Installation and Operation Instructions

RETROFIT KIT RET-041

For OPTIMOD-AM Model 9100A/1 (mono)

Purpose: Adds NRSC Pre-emphasis and 10kHz Low-pass Filter

Fig. 1: Jumper Positions, Card #7

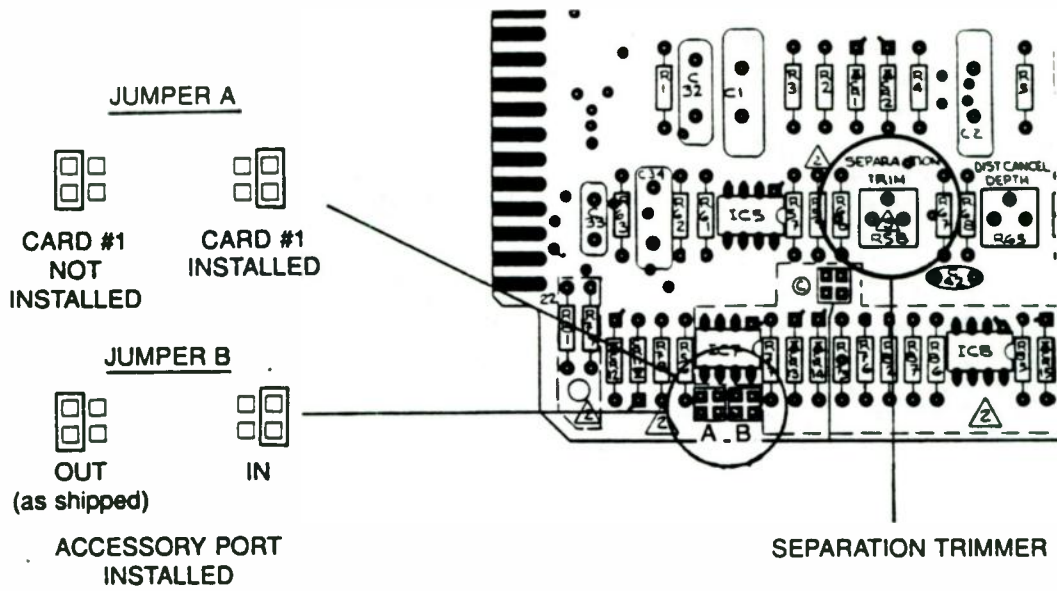
- a) Remove Card #7 from its slot.
- b) Place jumper A on Card #7 in the "CARD 1 INSTALLED" position (see Fig. 1).
- c) Return Card #7 to its slot.

Fig. 2: Jumper Positions and Component Locations, Card #4

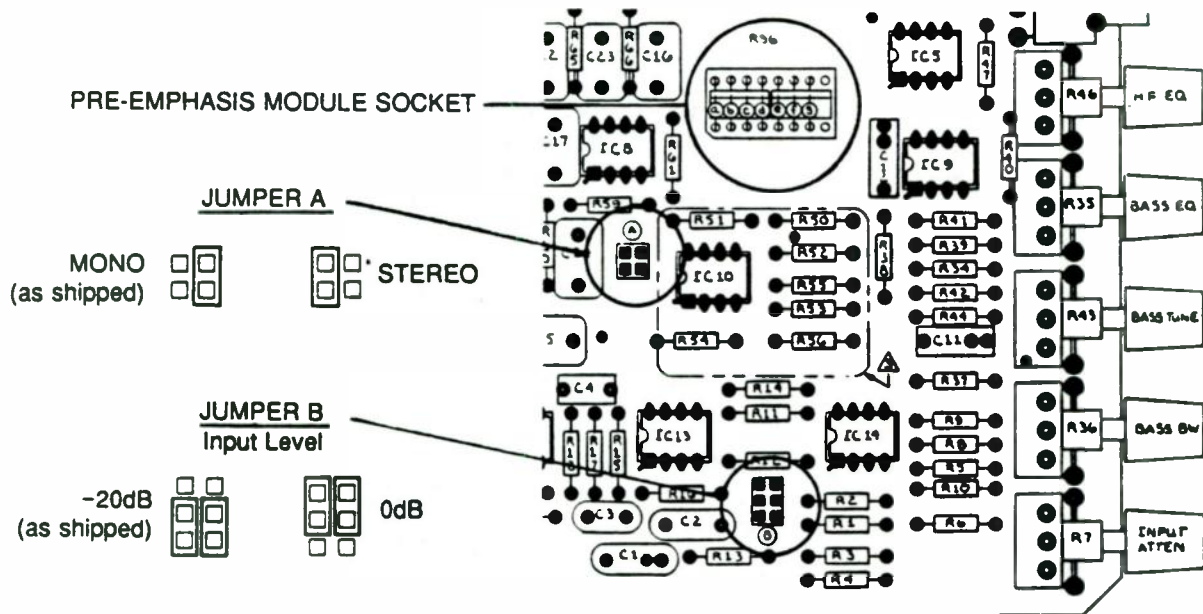
- a) Remove Card #4 from its slot.
- b) If the serial number of your 9100A/1 is below 700000, install Retrofit Kit RET-033 on Card #4 before continuing (instructions are provided with that kit).
- c) Unplug the "equalization module" from the socket on Card #4.
Do not remove the module if it is BLUE. See Fig. 2 for location of the module. (On some earlier versions of Card #4, the socket is on a "transition board" assembly.)
- d) Insert the BLUE NRSC pre-emphasis module in the socket.
- e) Check that jumper A on Card #4 is in the "MONO" position.
- f) Return Card #4 to its slot.

Fig. 3: Motherboard Modification
(Only for units with serial numbers below 700000)

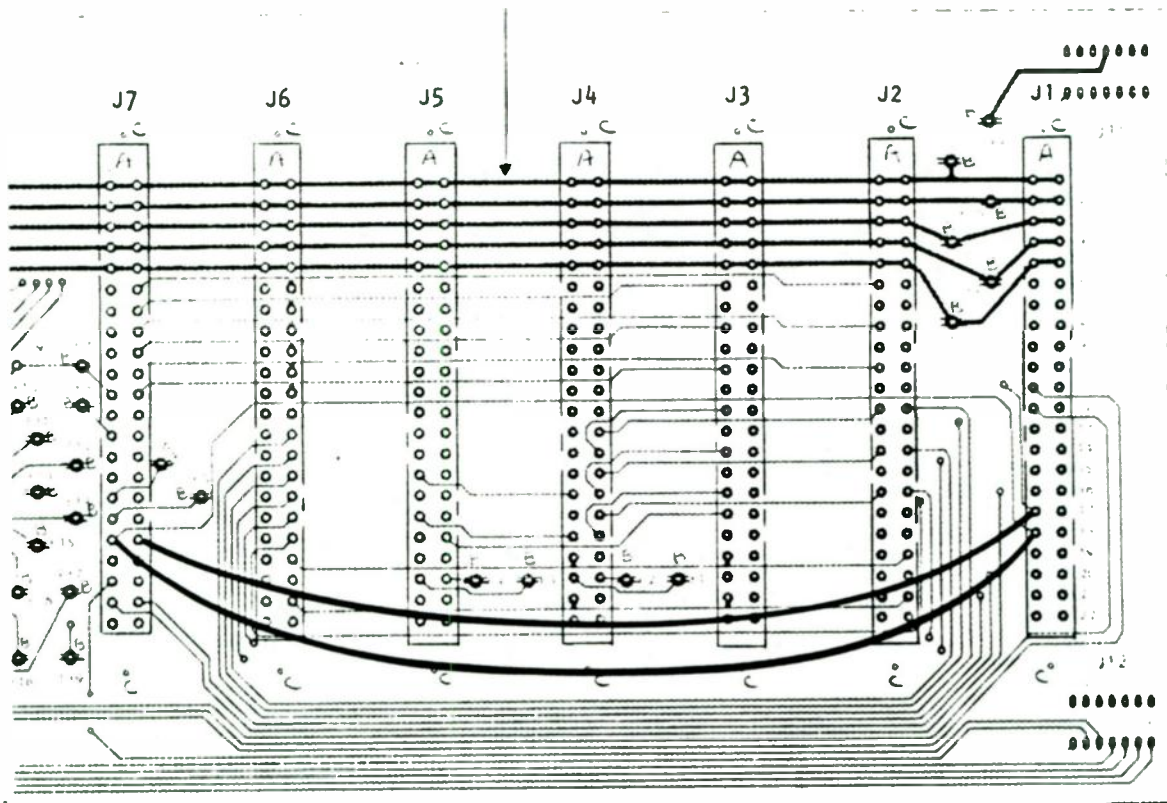
- l) On the motherboard, tack solder the supplied 30-gauge insulated hook-up wire from pin 7-18 to pin 1-U (see Fig. 3).
- m) On the motherboard, tack solder the supplied 30-gauge insulated hook-up wire from pin 7-V to pin 1-V (see Fig. 3).
- n) Check your work carefully. Measure the voltage between the chassis and pin U and between the chassis and pin V with the POS PEAK THRESH control fully counterclockwise (these voltages should be near -4.1VDC and +4.1VDC, respectively).
- o) *Very carefully* tilt the rear panel up to the vertical position, and the push the rear panel forward into place.
Take care that no wires are pinched between the panel and the chassis.
- p) Replace the 25 screws removed above.
Do not tighten screws until all screws are loosely in place.
- q) Return OPTIMOD-AM to rack, connect and ground unit.

Fig. 4: Low-pass Filter Jumper Positions, Card #1F10

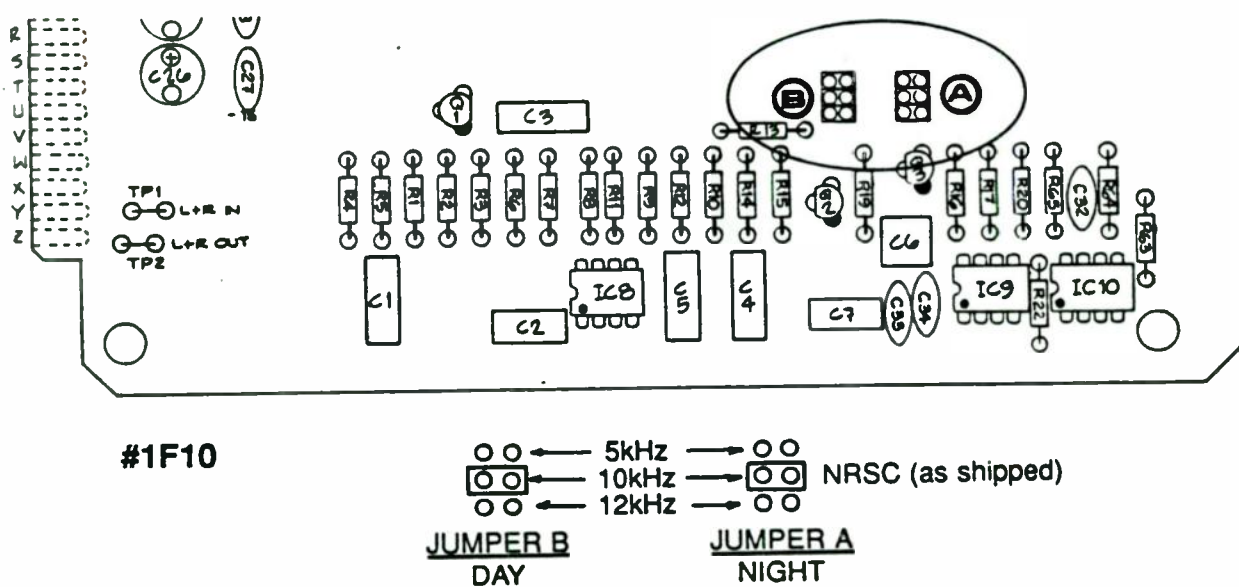
- a) Remove Card #1 or #1-F from slot #1, if present.
- b) Position jumpers A (night) and B (day) on Card #1F10 to select the desired low-pass filter (see Fig. 4).

You may select 5kHz, 10kHz, or 12kHz low-pass filtering in any combination for day and night operation. The NRSC standard specifies 10kHz low-pass filtering for both day and night.

Fig. 5: NRSC Simplified 75 μ s Monitor Rolloff Filter Schematic

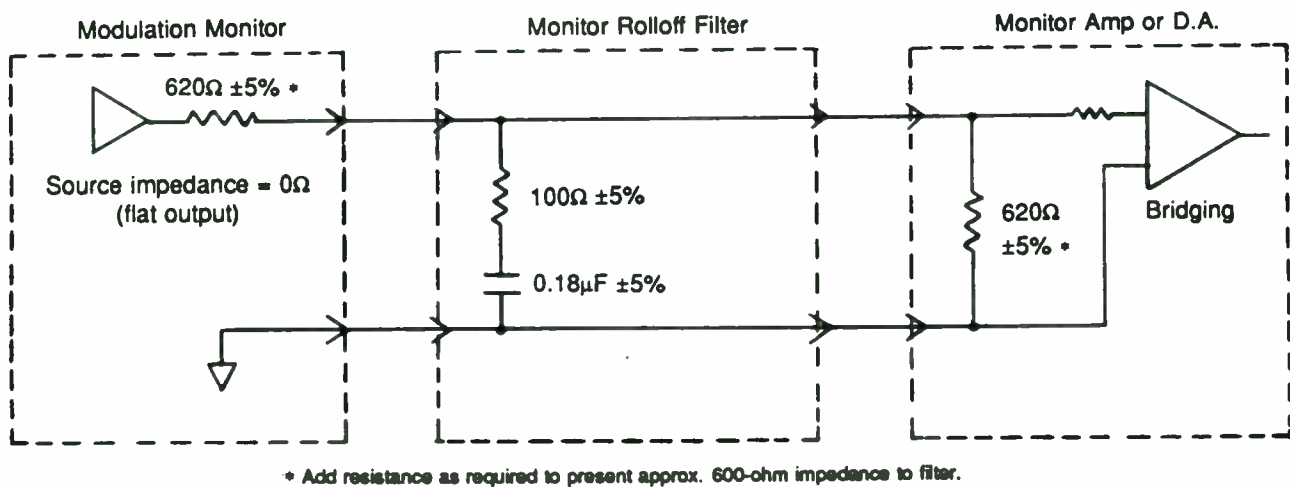
The ACC-5 Monitor Rolloff Filters supplied with 9100A/1 units were designed to complement the original GREEN module. When the BLUE module is used, a simple de-emphasis circuit can be placed between the audio output of the modulation monitor and the input of the monitor amplifier to provide complementary 75 μ s de-emphasis. For a more precise simulation of a "standard" NRSC receiver (including a 10kHz notch filter to reduce any audible artifacts that might result from ringing introduced by the very sharp 10kHz low-pass filter, and to eliminate 10kHz whistles encountered in off-air monitoring), we recommend our ACC-023 NRSC Monitor Rolloff Filter.

See Fig. 5 for a schematic of the simplified rolloff filter and information about installing it (the parts needed are included in this kit). Note that the frequency response of this filter is correct only when *both* its source and load impedances are approximately 600 ohms, and that resistors or pads may have to be added to achieve this.
